FAIR PLAZA
5
ASSOCIATES

LOTS 10 THRU 18
BLOCK 26
VALLEY VIEW ADDITION

225 Jefferson

RE: DRAINAGE PLAN SUBMITTAL OF VALLEY VIEW ADDITION
LOTS 10 - 18, BLOCK 26 RECEIVED APRIL 29, 1986 FOR
BUILDING PERMIT APPROVAL (K-17/D43)

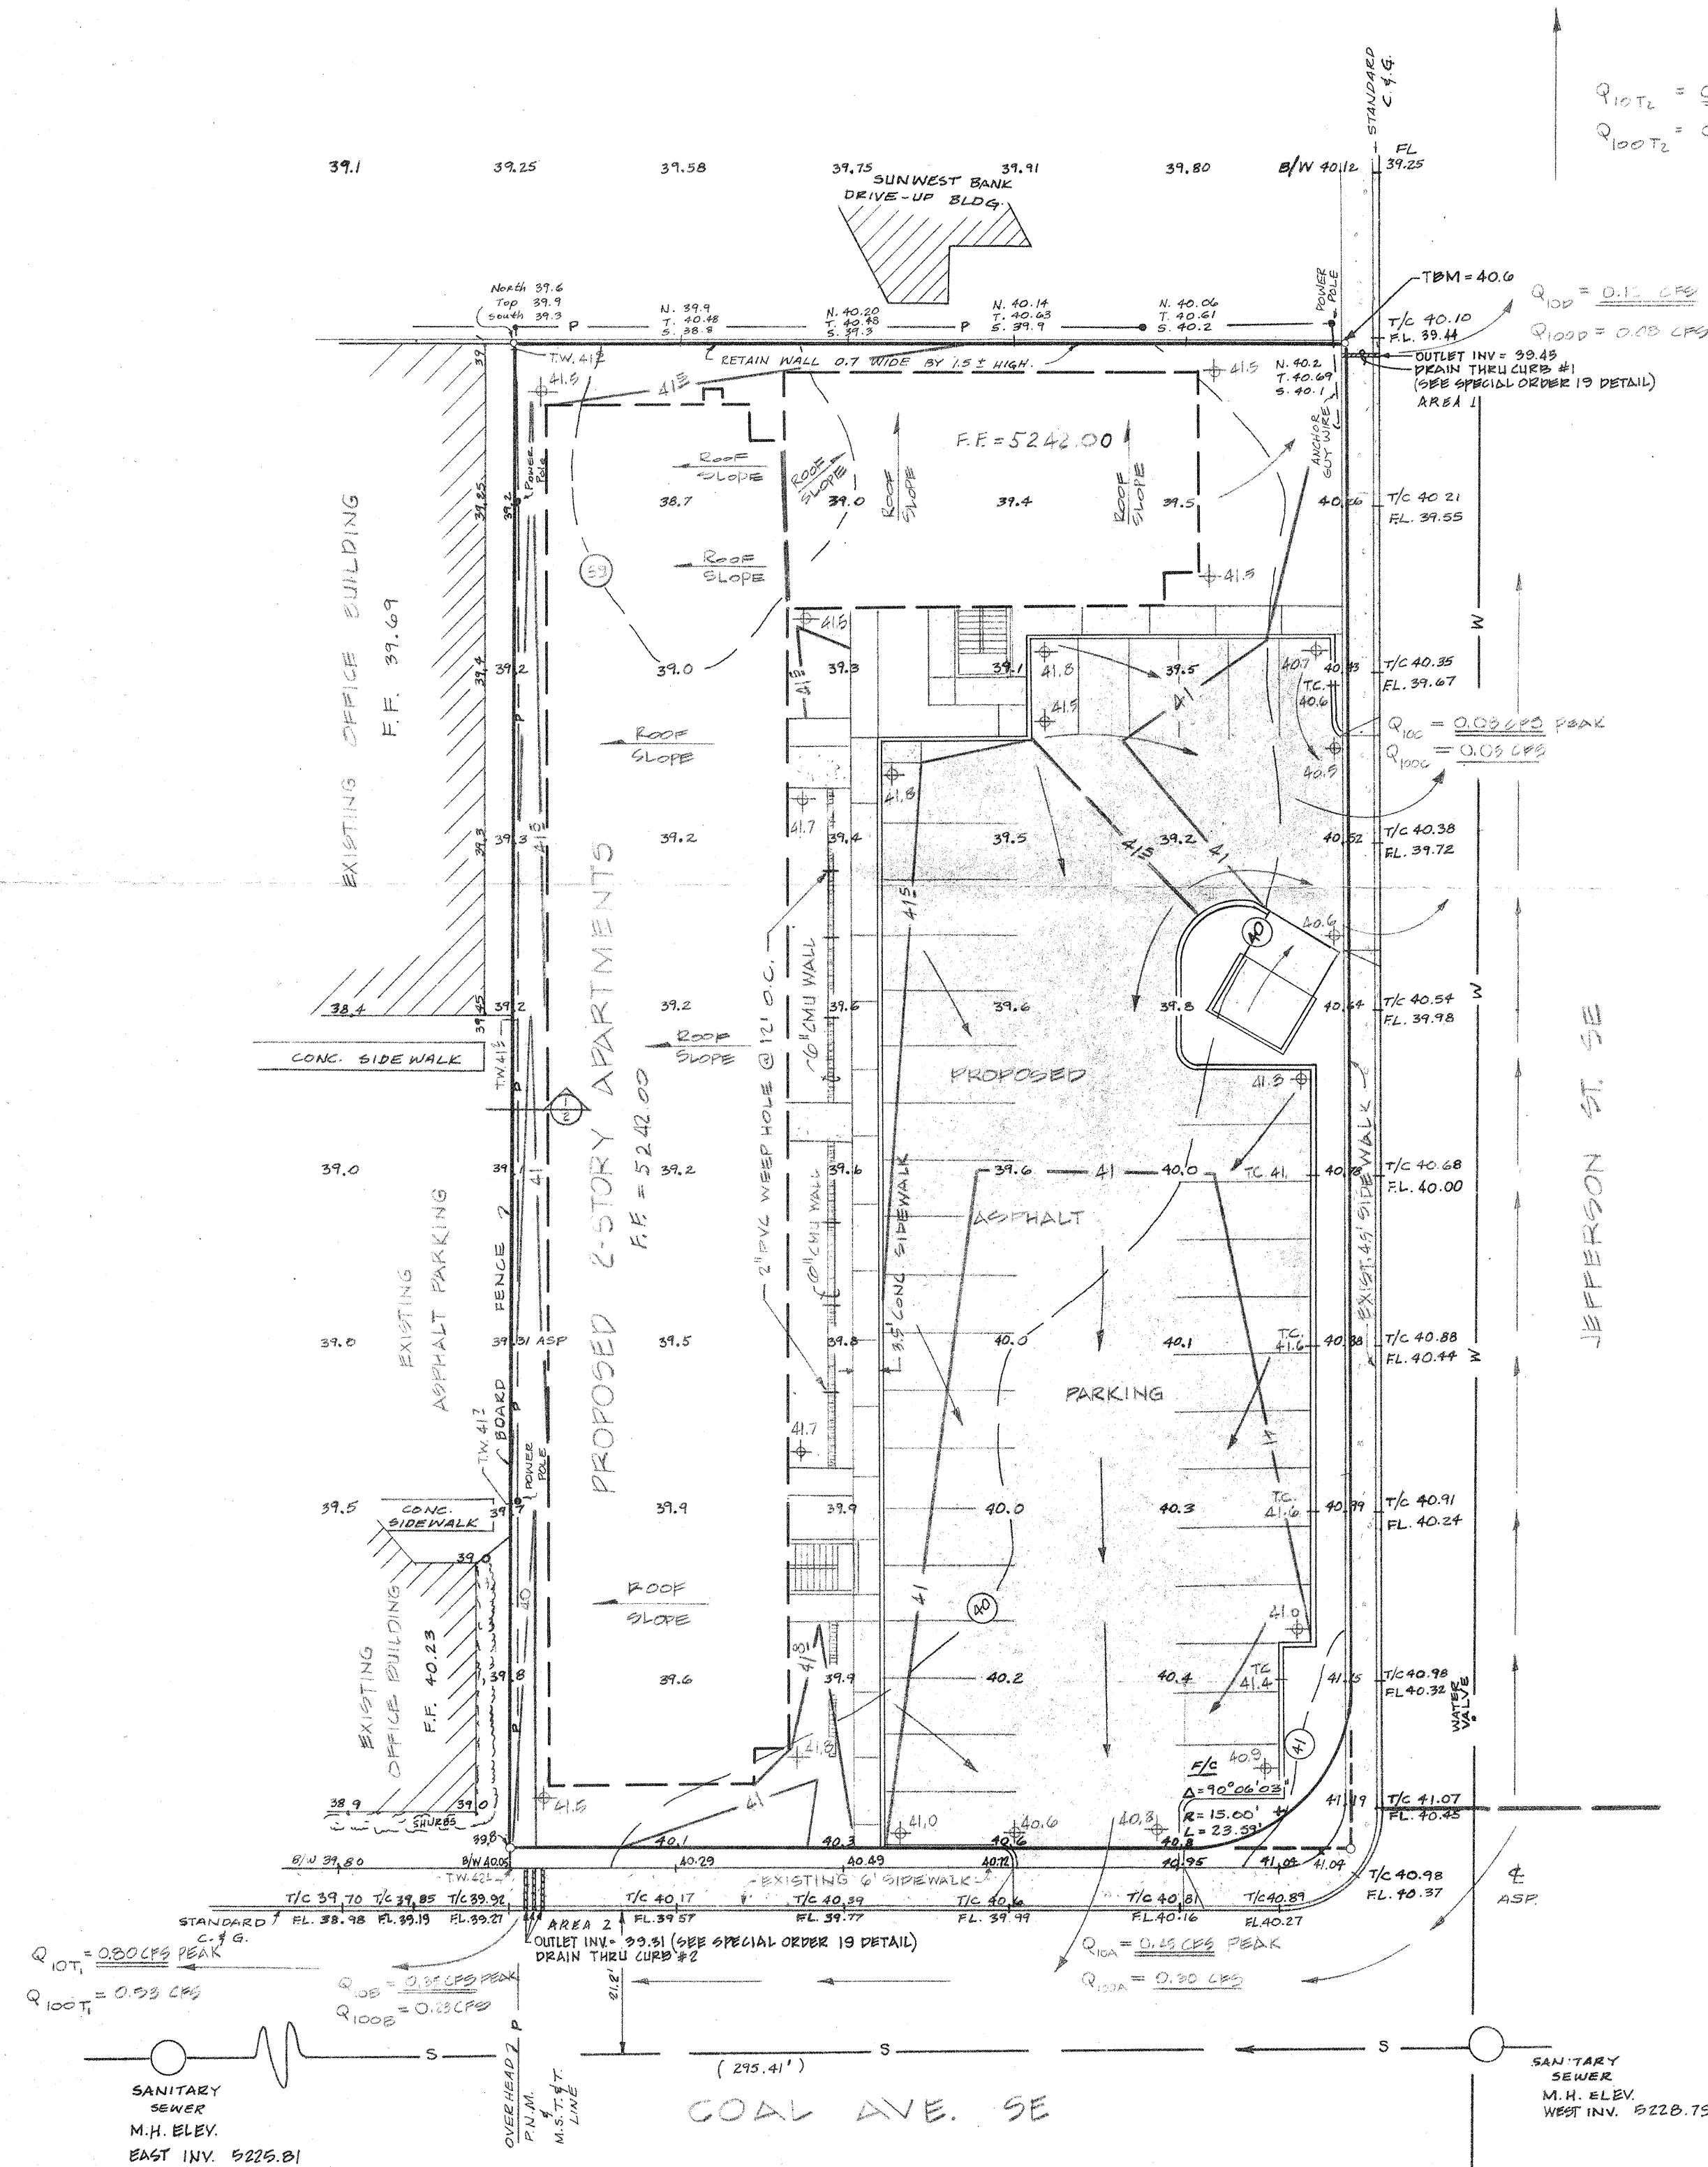
The above referenced submittal, revised April 28, 1986, is approved for Building Permit, provided two four inch (4") PVC curb drains are added to drain #2 into Coal Avenue. This was discussed with you today.
